Project	IEEE 802.16 Broadband Wireless Access Working Group < http://ieee802.org/16 >	
Title	In-band Semi-transparent Relay Frame Structure	
Date Submitted	2006-04-04	
Source(s)	Kanchei (Ken) Loa, Yi-Hsueh Tsai, Yung-Ting Lee, Heng-Iang Hsu Shiann-Tsong Sheu, Frank C.D. Tsai, Youn-Tai Lee, Chih-Chiang Hsieh, Hua-Chiang Yin, Institute for Information Industry 8F., No. 218, Sec. 2, Dunhua S. Rd., Taipei City, Taiwan. [add co-authors here]	Voice: +886-2-2739-9616 loa@iii.org.tw
Re:	IEEE 802.16j-07/013: "Call for Technical Comments Regarding IEEE Project 802.16j"	
Abstract	This contribution proposes in-band semi-transparent relay frame structure	
Purpose	Text proposal for 802.16j Baseline Document	
Notice	This document has been prepared to assist IEEE 802.16. It is offered as a basis for discussion and is not binding on the contributing individual(s) or organization(s). The material in this document is subject to change in form and content after further study. The contributor(s) reserve(s) the right to add, amend or withdraw material contained herein.

In-band Semi-transparent Relay Frame Structure

Figure xxx Example of configuration for an in-band semi-transparent relay frame structure

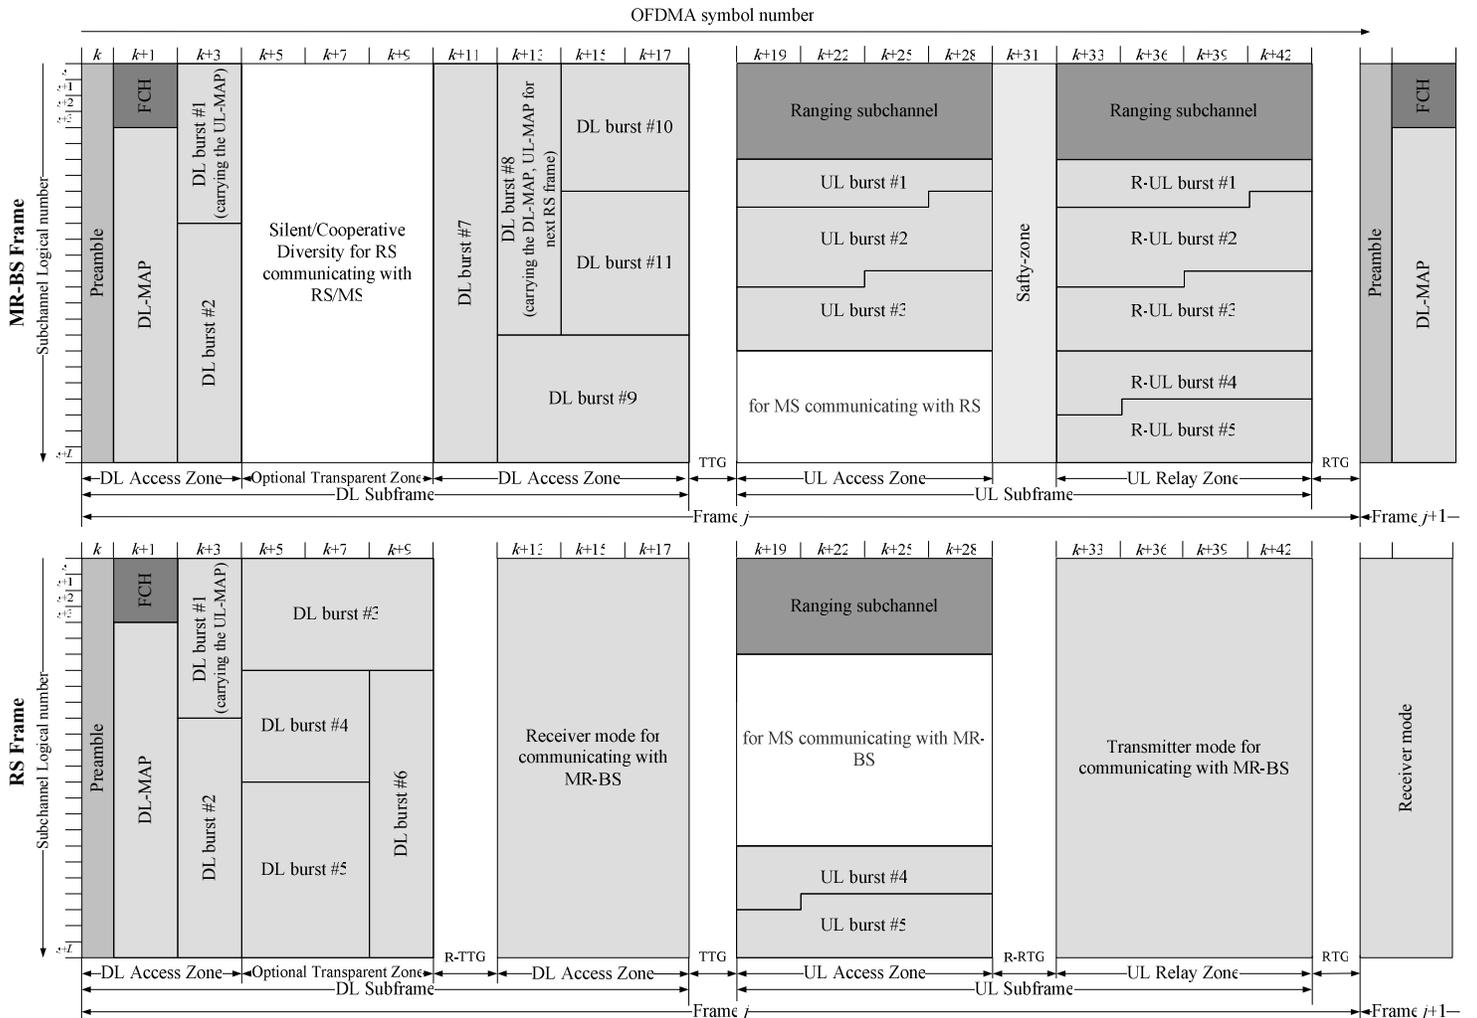
For the TDD mode, an example of the MR-BS frame structure is shown in Figure xxx.

Each frame in the downlink transmission begins with a preamble followed by an FCH, DL-MAP, and possibly UL-MAP. The frame structure consists of DL sub-frame period and UL sub-frame period. In each frame, the TTG shall be inserted between the DL sub-frame and the UL sub-frame. The RTG shall be inserted at the end of each frame.

The DL sub-frame shall include at least one zone for both MR-BS and RS to its subordinate MS simultaneously, may optionally include a transparent zone for RS to its subordinate stations transmissions and may include an access zone for MR-BS to its subordinate MS/RS transmissions. Optionally the MR-BS may transmit in the transparent zone as well. The transparent zone can be indicated by STC_DL_ZONE_IE() defined in Table 279. The UL sub-frame may include a zone for MS to its access station transmissions and optionally include a zone for RS to its access station transmissions. The bandwidth allocation for transmissions between MR-BS and MS / RS follows IEEE802.16e operation.
